glasstech, inc.

Service Bulletin

Modification to Honeywell UDC100 Micro-Pro Universal Limit Controller Reference 015

Figure 1

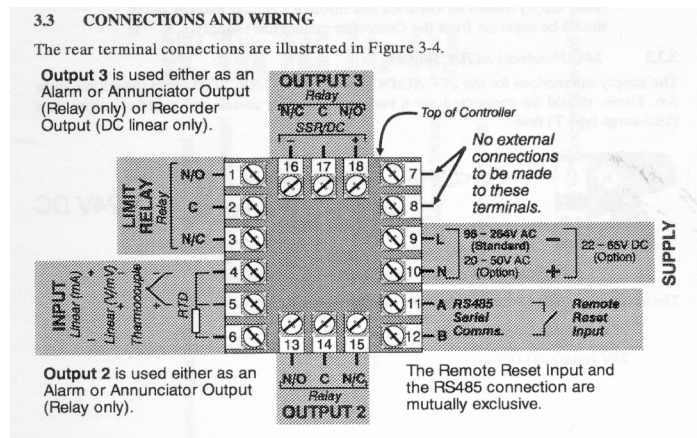
Glasstech requires a change in the output wiring for those gas fired heating systems that use the Honeywell UDC100 Micro-Pro Limit Controller for high temperature safety shutdown.

As originally wired and configured, the controller will safely shut down a burner that exceeds the high temperature limit setpoint. Once the high temperature cools to a point below the high temperature setpoint the system will initiate a re-ignition sequence and re-light the burner.

The Factory Mutual (FM) listing of this device as a safety shut down control requires manual operator intervention to reset the controller latching relay before re-starting the burner.

The wiring for the high temperature limit shutdown interlock needs to be removed from the Output 2 Relay (non-latching) to the Limit Relay (latching manually reset).

See figure 1 below for description of the required changes.

- Step 1 – De-energize the combustion system panels.
- Step 2 – Remove wires from terminals 14, 15.
- Step 3 – Re-install wires on terminals 1, 2.
- Step 4 – Return combustion panels to normal service.
